APPLICATION NUMBER: 25/0177

PROPOSAL: THREE COMMERCIAL UNITS no 19-21

SITE: Llanwern Works

APPLICATION TYPE: Reserved Matters

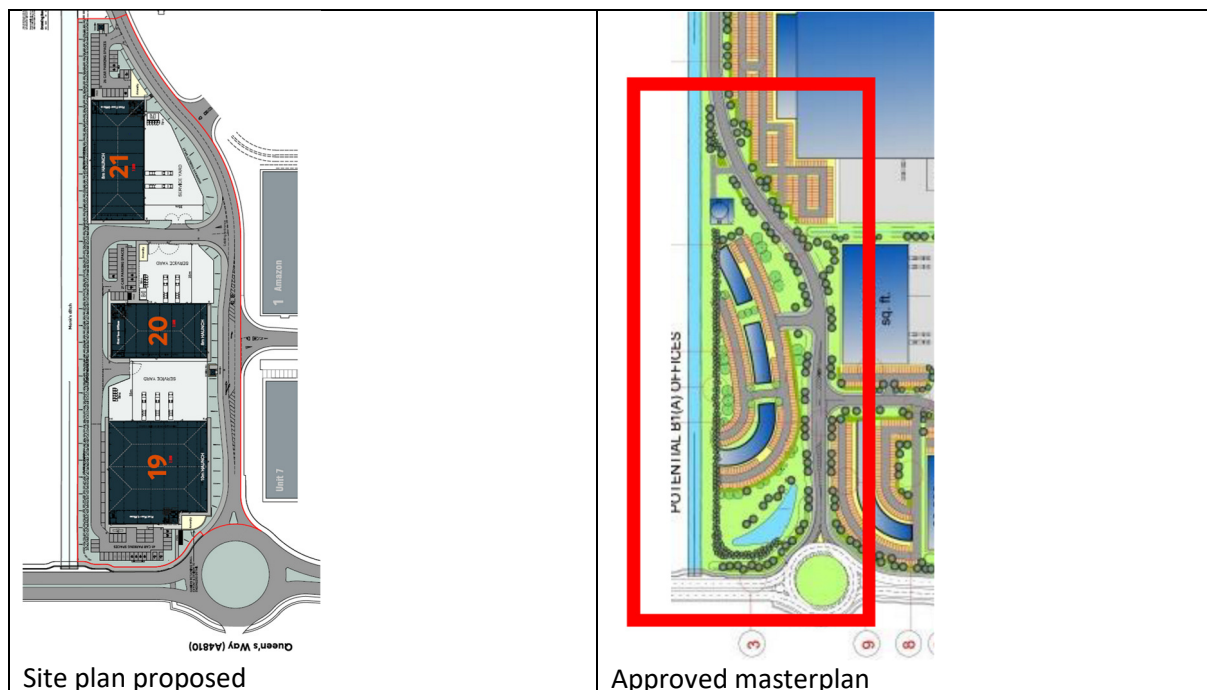
SIGNIFICANT DEVIATION FROM APPROVED MASTERPLAN WITH LANDSCAPE IMPACTS ALSO AFFECTING GLAN LLYN

The proposal is for Use Classes B1, B2 and/or B8 whereas the approved masterplan shows B1(A) offices. The larger scale buildings required for B8 use are more difficult to assimilate into the landscape and will result in a higher landscape impact, affecting Glan Llyn users and residents to the west of Monks Reen.

Landscape concern along Monks Ditch arises from:

- the extensive use of gabion baskets, this is not a high-quality solution to level changes and indicates an over-developed site.
- impact from unit 21 where space is so tight there is insufficient room to accommodate even a hedge. No structural planting (trees, hedges) is shown and the rear of the building will be openly visible across Monks Ditch affecting residents and users of the football pitches, pavilion and LEAP.
- the proposal is not in line with the approved Celtic Business Park masterplan or description of planting along Monks Ditch (below).

The concerns are driven by the Site Plan, there is no more that planting mitigation can deliver.

I would strongly recommend the layout is revised to accommodate trees and hedges and allow a continuous landscape character along Monks Ditch as shown for units 19 and 20.

It would help further analysis and discussion if the landscape context within Glan Llyn and along Monks Ditch could be shown in plan view and a landscape drawn section (by rps) provided to illustrate the relationship between the scale of the units, the ditch, and to show the context within Glan Llyn.
